Enclosed for your information is a copy of the Class II Project Interface Document (PID) No. 03-S-39-01 for the Durango, Colorado, Uranium Mill Tailings Remedial Action site. A revision to the previously submitted PID has been made which includes a cross-section view of the southwestern berm on Ditch No. 2, and the addition of type "B-C" riprap to the outlet on the southeastern edge of Ditch No. 2.

UMTRA PROJECT OFFICE
PROJECT INTERFACE DOCUMENT

Site Durango	Date 11/06/90	PID No. 03-S-39 Rev1	Site No. 03	Vic Pro No.
Originator and Location M.L. Wesely, SF	Phone (415)442-7517	Organization MKFS	Answer By:	References: Subcontract: Subcontract No: DUR-86-02
Subject 1) Redesign of Drainage Outlet Along Ditch No. 2, 2) Rock Soil Matrix Range for Mixing Ratios, and 3) Add Erosion Protection to the 7:1 Slope Outlet of Section S

FIGURE 1: REVISION TO TOE OF FILL FOR DITCH NO.2 BERM (P.I.D. 03-S-39)

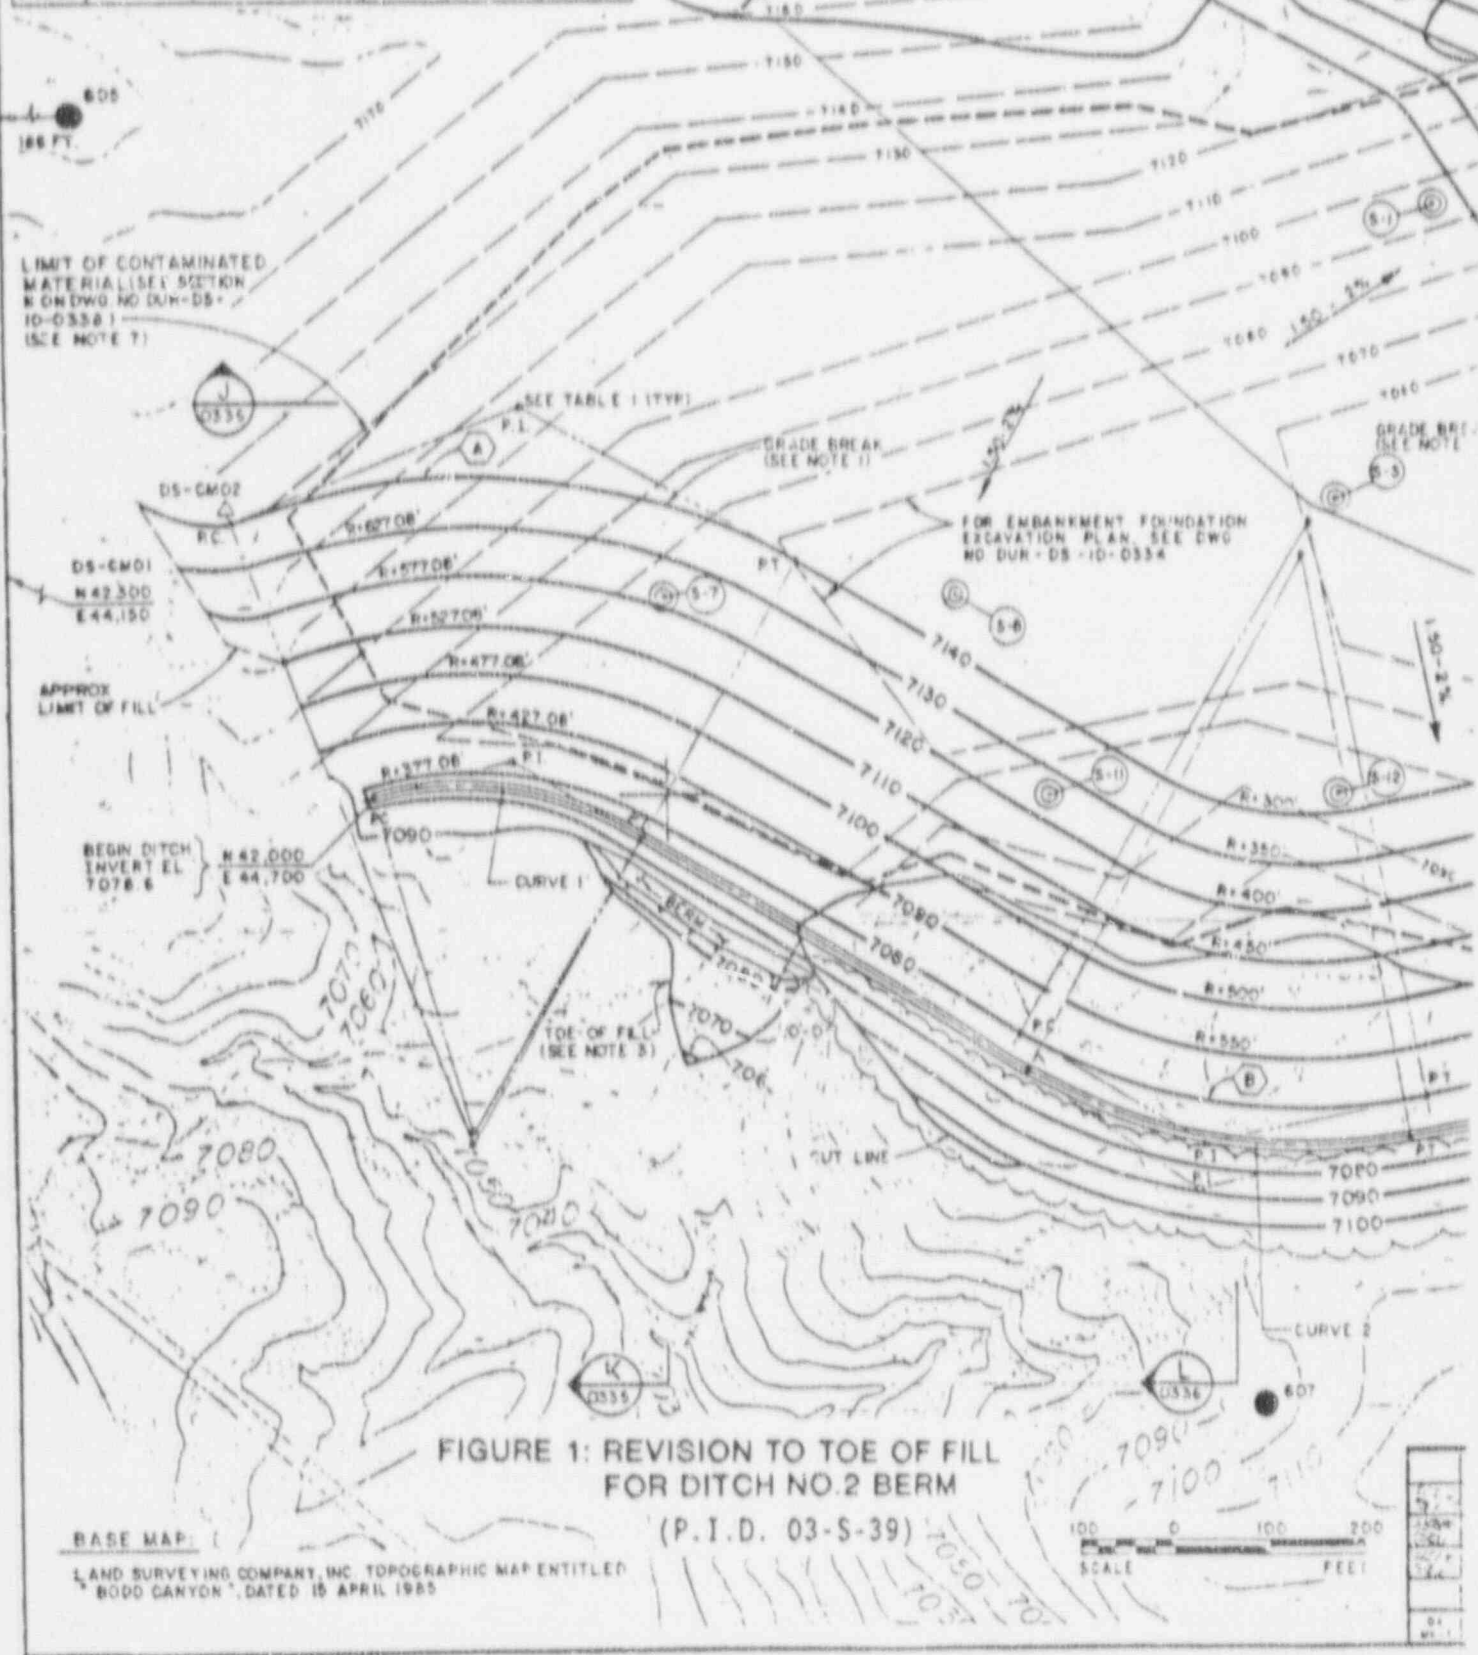
PROBLEM 1: As part of the final site restoration, the southwestern corner of the Durango disposal site will be backfilled with excess material from ditch excavations. This area encompasses a portion of the southern edge of Ditch #2 including a region which had previously been designed as a drainage feature for the ditch. Construction activities in the region had changed the topography from the original contours shown on the construction drawings. Fill will be placed over the entire region at a mild slope flatter than 10:1 horizontal to vertical. The original design of the key trench and drainage feature was to tie into natural topography at a 5:1 slope. The proposed flattening of the slope would change the basic design requirements for erosion protection in this region, the key trench and riprap on the slope would be redundant. Precipitation falling on the area would runoff as sheetflow and not as concentrated flows. Removal of the trench and riprap would also be a cost savings.

SOLUTION 1: Revise Drawings DUR-DS-10-0335 and DUR-DS-10-0337 per attached Figures 1 and 2. Add Note 6 to drawing DUR-DS-10-0337 to read: "6. Fill shall be placed adjacent to Ditch No. 2 to provide sheetflow runoff away from the ditch berm to the existing drainage at the southwest corner of the site." [Add Section Z to drawing DUR-DS-10-0340 and change Section S to Section Z on the southwestern berm on Ditch No. 2 (Figure 3).]*

- o Add fill on the south and southwest regions at a gradient of 10:1 or flatter with the tie into the south boundary drainage channel at 2.5:1 or flatter.
- o Remove the previously designed key trench and spillway.

FIGURE 4 - ADDITION OF RIPRAP B-C TO 7:1 SLOPE

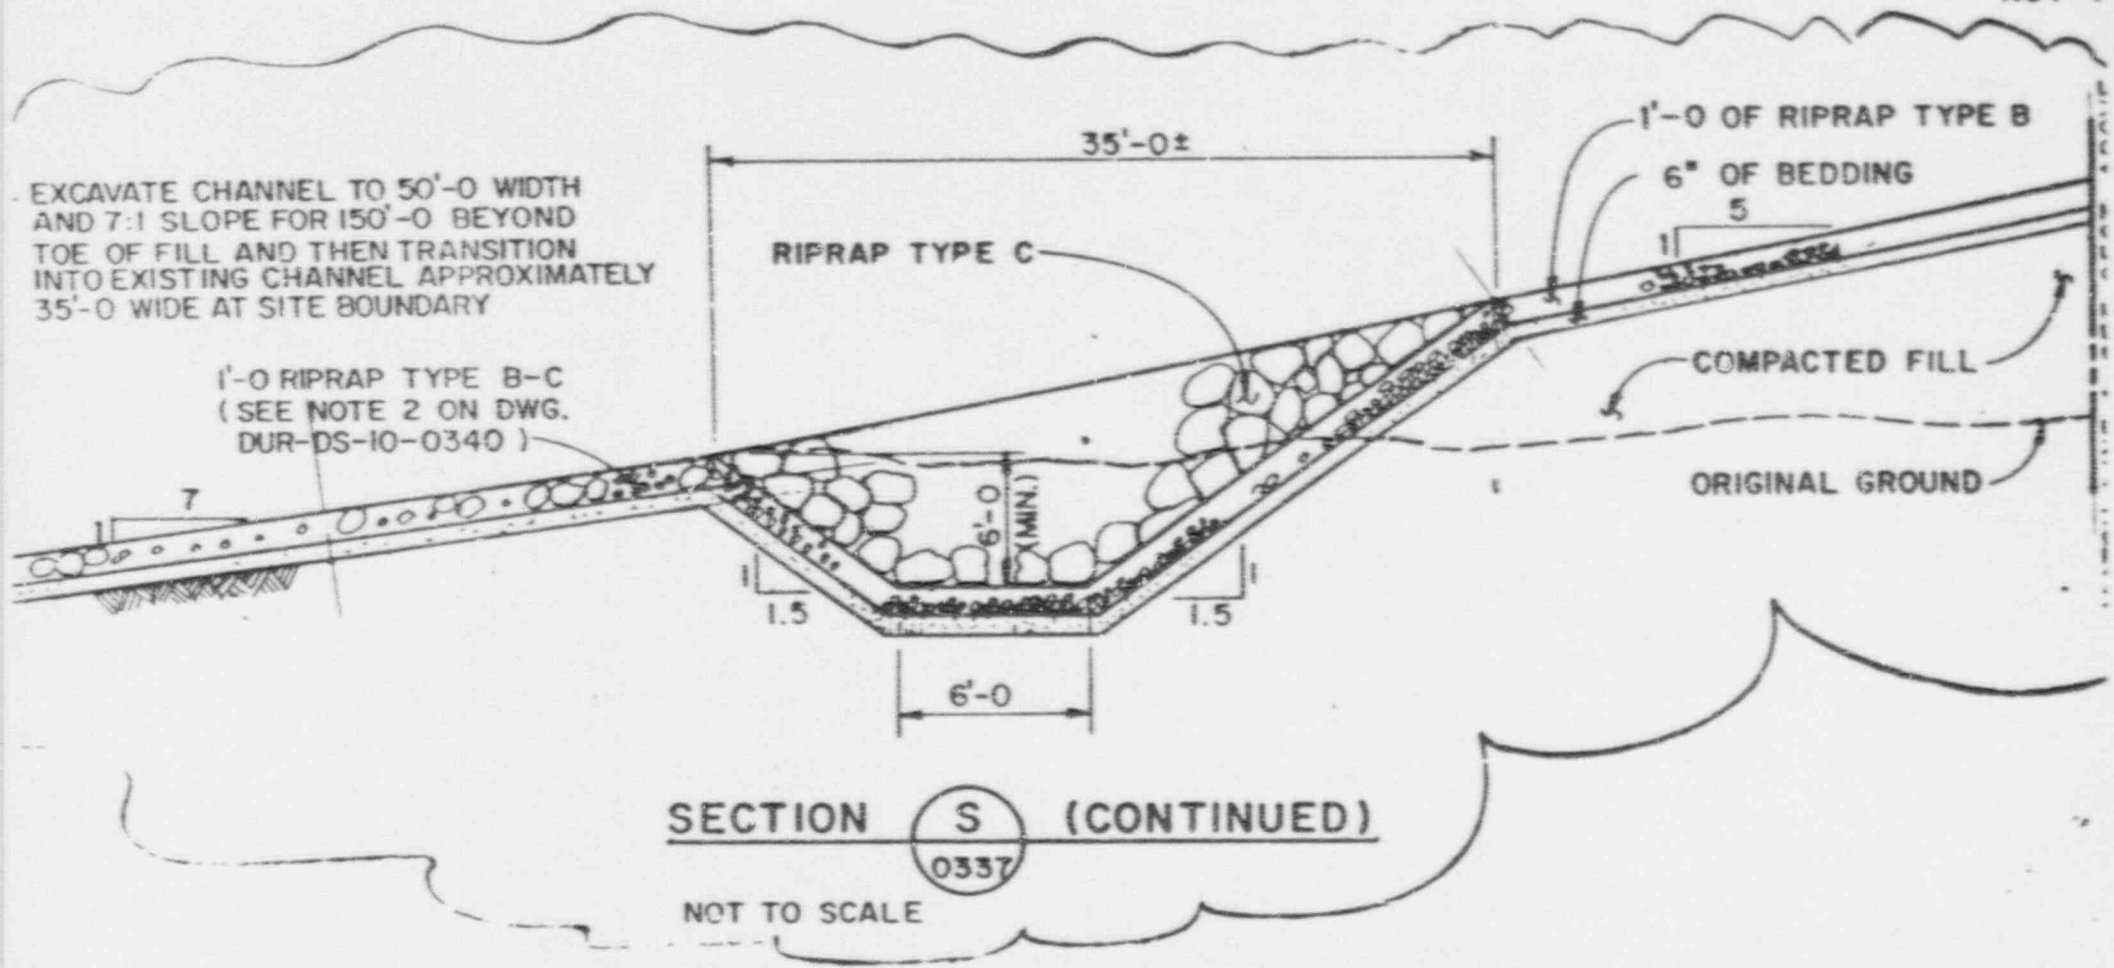
PROBLEM 3: Potential erosion is foreseen on the unarmored 7:1 slope of the outlet of cross-section S on the southeastern edge of Ditch No. 2.

SOLUTION 3: Add Riprap B-C to the bottom of the Section S outlet on Drawing DUR-DS-10-0339 and Drawing DUR-DS-10-0337 similar to the riprap apron of Ditch No. 1 (Figures 4 & 5). Change corresponding elevation contours on Drawing DUR-DS-10-0335 to reflect addition of 1 ft of Riprap B-C and 6 inches of bedding.] *
